High Wycombe Town Centre Masterplan

Stage 1 Road Safety Audit

Project: High Wycombe Town Centre Masterplan
Client: Transport for Buckinghamshire Project No: B1279846
 Wycombe District Council
Document title: Stage 1 Road Safety Audit
Ref. No: B1279846/RSA_1/Final

Photo 7 - The existing zebra crossing is located very close to the car park exit.

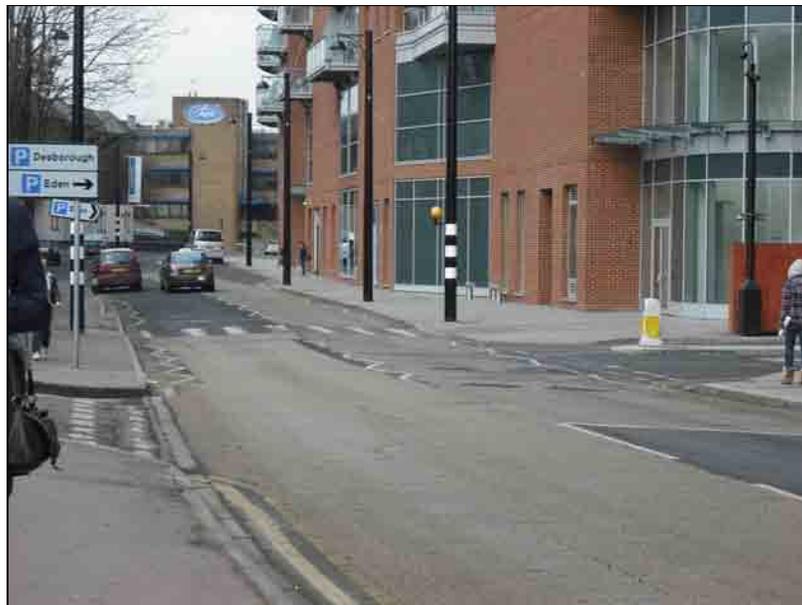
Location	Lily's Walk, west of car park entrance/ exit.
Summary	Location of existing pedestrian crossing.
Description	There is an existing zebra crossing to the west of the Eden Centre car park entrance. During the site visit it was noted that the pedestrian crossing was located very close to the car park exit (see photo 7). Drivers exiting the car park have to consider vehicles approaching from two directions as well as pedestrian movements. The design of the scheme does not look to improve this situation; in fact the situation could worsen with an additional lane being added on Lily's Walk.
Recommendation	Relocate the crossing slightly further away (westward) from its current location.

4.11	Enforcement of left turn only.	Street furniture has not been provided at this location as requested by the Client to allow emergency and winter maintenance vehicles to carry on along Lily's Walk and on to Desborough Road. As such an exception is proposed at this location.
4.14	Provision for the visually/mobility impaired.	Safe and convenient crossing points are provided for visually/mobility impaired users by the raised crossings. The exact layout of the crossing facilities e.g. positioning of tactiles, etc. are to be undertaken as the design progresses through the preliminary and detailed design stages.
4.15	Location of existing pedestrian crossing.	An informal raised crossing is provided further west of the existing Zebra crossing.
